HISTORIC AND DESIGN REVIEW COMMISSION

June 21, 2017

HDRC CASE NO: 2017-190
ADDRESS: 100 AUDITORIUM CIRCLE
COMMON NAME: Veteran's Memorial Plaza
LEGAL DESCRIPTION: NCB 180 BLK LOT 16 (BEXAR COUNTY PERFORMING ARTS CENTER)
ZONING: D, H
CITY COUNCIL DIST.: 1
DISTRICT: Auditorium Circle Historic District
APPLICANT: Orville Fulkerson
OWNER: City of San Antonio
TYPE OF WORK: Relocate existing monument to a new location in the park
REQUEST:

The applicant is requesting a Certificate of Appropriateness for approval to relocate the existing 881st Monument from the SW corner of the park to the north central section of the park.

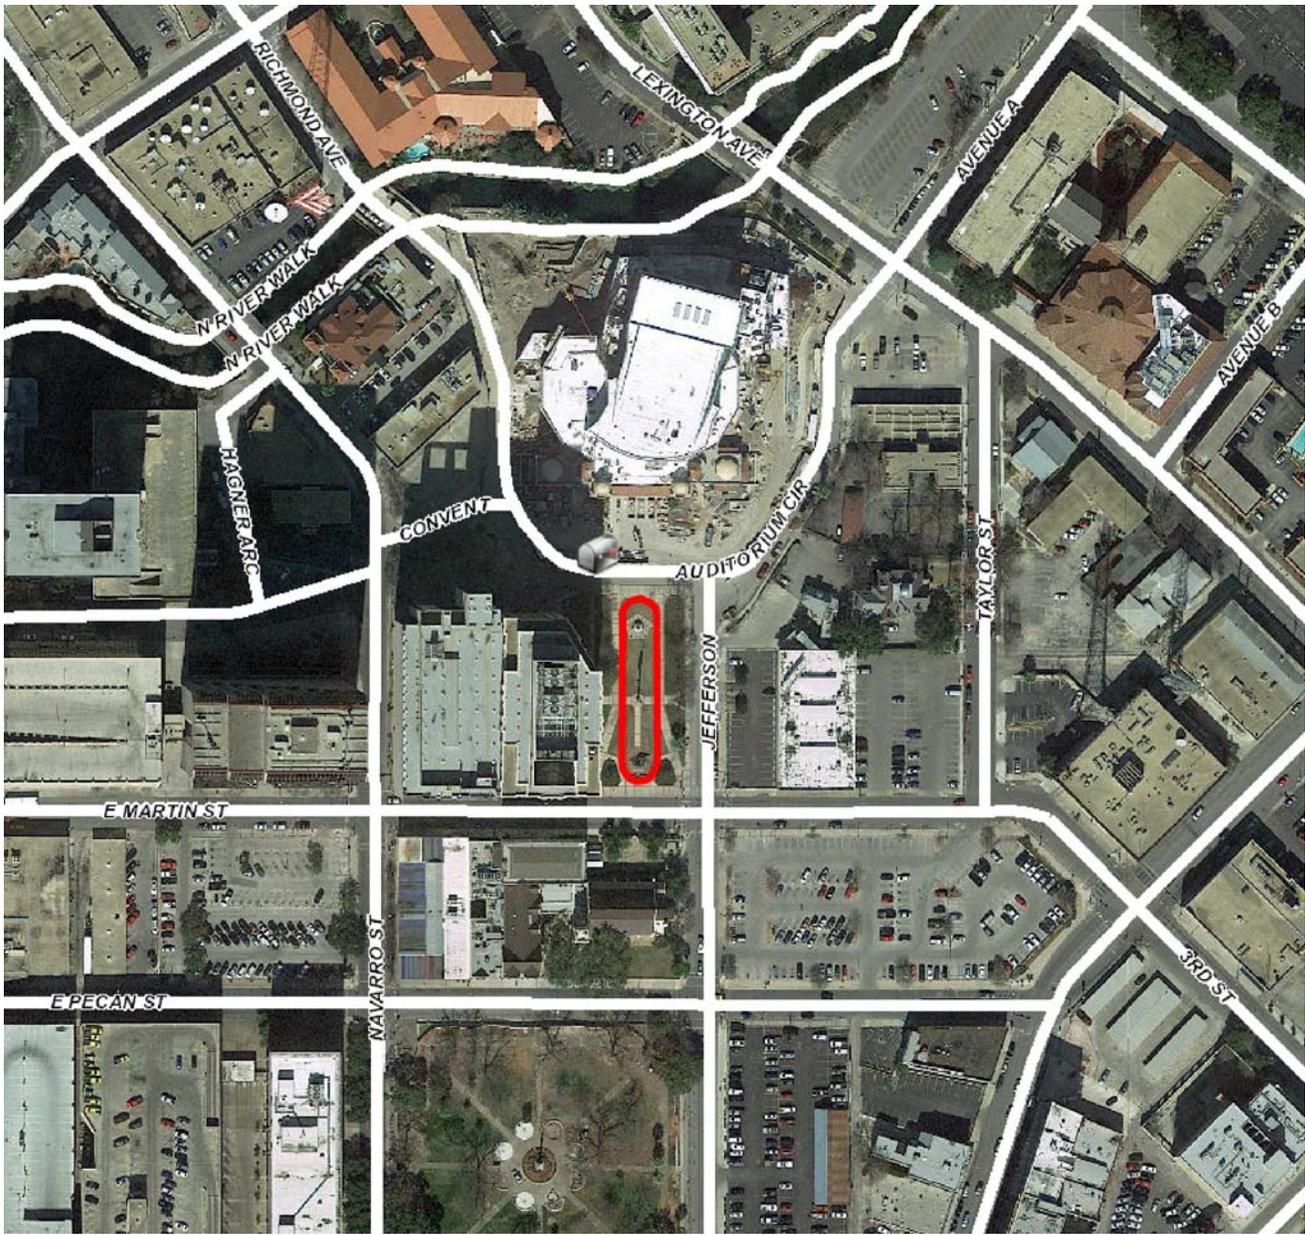
- a. The applicant has proposed to relocate an existing Vietnam Veterans Memorial at 100 Auditorium Circle in the Vietnam Veterans Memorial Park. At the October 5, 2016, HDRC hearing, the HDRC approved as master plan for Veterans Memorial Plaza which includes the preferred location of this monument. The location and
- b. Staff finds the current location of the monument is consistent with the approved master plan. Sufficient information which supports an amendment to the approved master plan has not been provided by the applicant.

Staff does not recommend approval based on findings a and b.

Slide # 3, Photo of monument at original site.

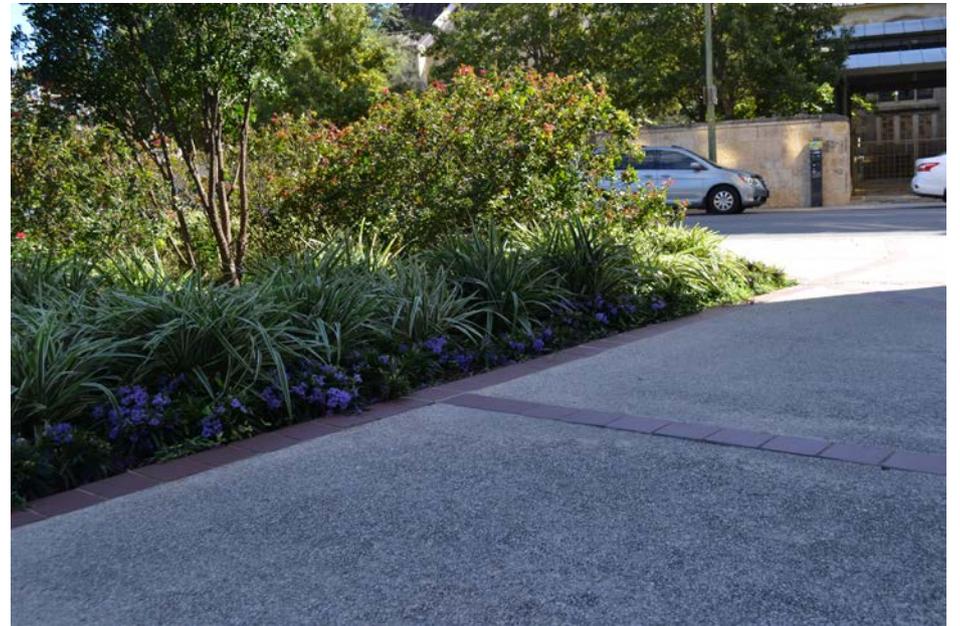
Slide # 4, Monument at its present site facing statue and Martin St., just like an advertisement. Over two years ago this was my first choice. This was a good choice but not the best. Now today the back of this planter where the monument sits is where folks walk and relieve their dogs, and at night this becomes a street person urinal.

Slide # 5 Shows the back of the planter within 10 ft. of monument, nuff said.

Slide # 6, Hard fact, the design is 180 degrees, now sits in 360 degrees. A 180 design in 360 setting is not correct. Monument has two pieces of angle iron in back for safety. This is a unacceptable design function.

Slide # 9, Monument is to close to public. Now sits at knee height level.

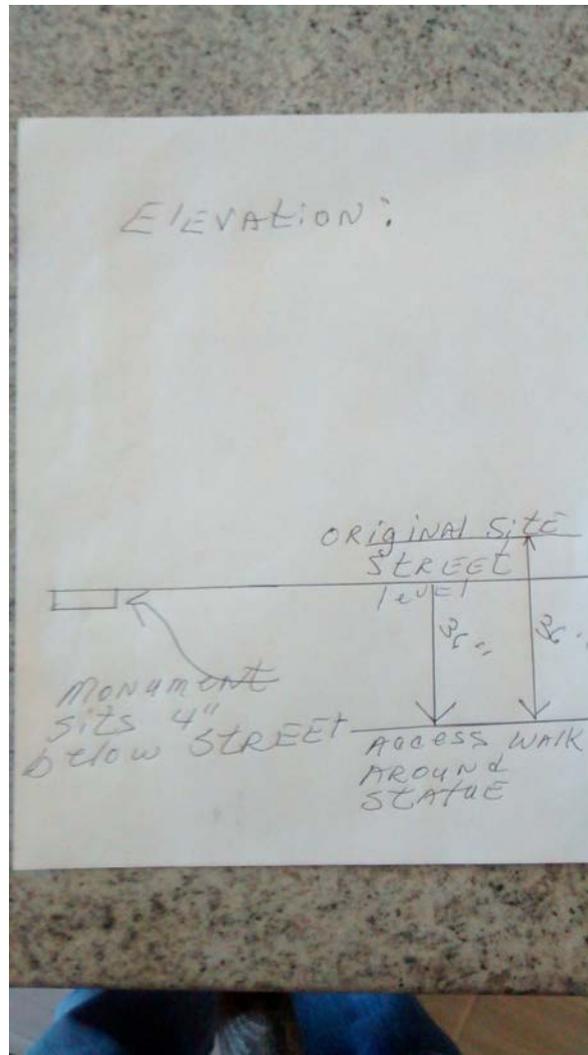
Slide # 10 , Elevation monument sits below street level by 4 inches.
